DATE: August 17, 2021

ARC REVIEW CODE: R2107281

TO: Chairman Phillip Beard, City of Buford
ATTN TO: Kim Wolfe, City Clerk/Planning Director
FROM: Douglas R. Hooker, Executive Director, ARC
RE: Development of Regional Impact (DRI) Review

Name of Proposal: Thompson Mill Road Project DRI #3279

DRAWING / SHEET TITLE
DRI #3279 SITE PLAN

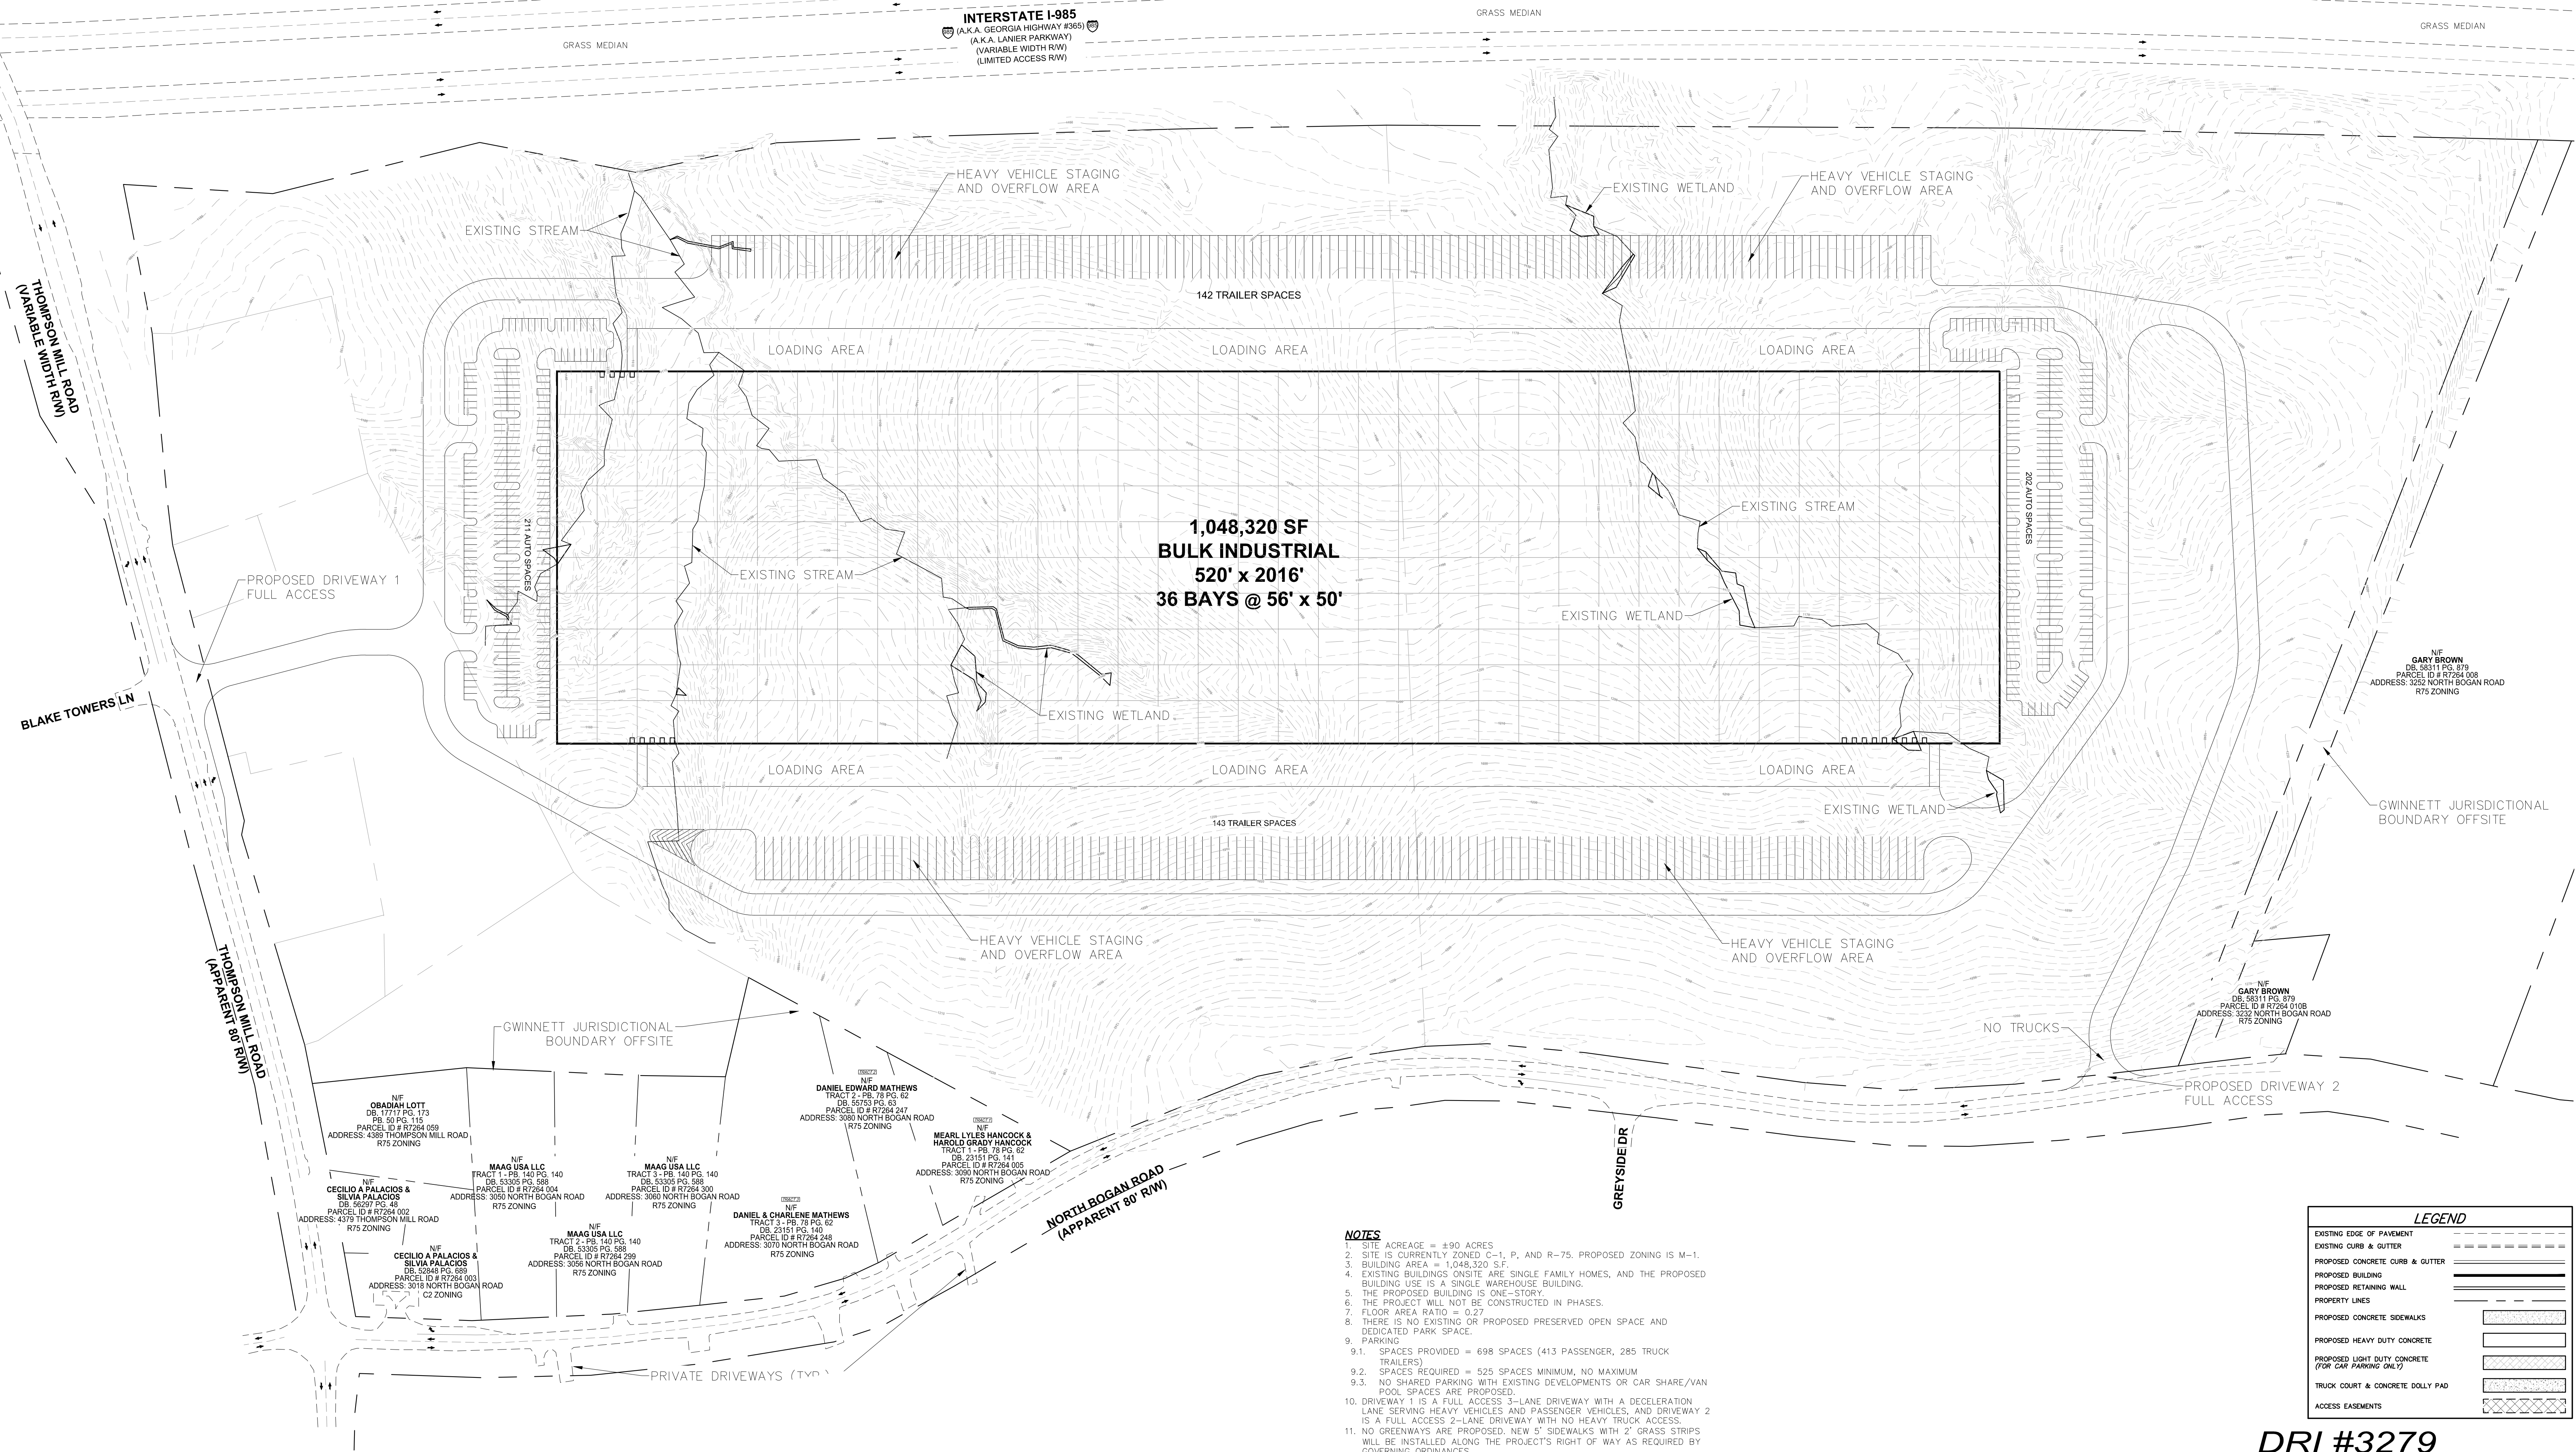
In addition, ARC encourages the applicant team to ensure that the development promotes a functional, safe, clearly marked and comfortable pedestrian experience on all proposed driveways, paths and parking areas on the site. This framework can offer the potential for safe internal site circulation for employees on foot or by another alternative mode.

The DRI's site design should provide sufficient truck parking to prevent trucks from queuing or waiting on adjacent or nearby roads. Trucks parking in and along public roadways – typically while waiting for an available dock at a nearby facility – is an identified issue in many areas of the region that negatively impacts roadway operations, safety and congestion. The traffic impact study prepared by this DRI applicant's engineer indicates that the project's internal queueing plan and site design are anticipated to accommodate all trucks within the site and not impact the external roadway network. City and County officials should ensure that this is the case once the DRI is built and remains so.

Signage and other measures to ensure that truck drivers accessing this site use the appropriate freight routes, should also be emphasized. This will be important in relation to N. Bogan Rd., which is a restricted road with posted "no trucks" signage. This means "no trucks" signage should be posted for any heavy vehicles that attempt to exit the project onto N. Bogan Rd. In addition, if the intersection of Thompson Mill Rd. and N. Bogan Rd. is not already signed as such, "no trucks" signage should be posted there as well, for any heavy vehicles that attempt to approach the site via N. Bogan Rd.
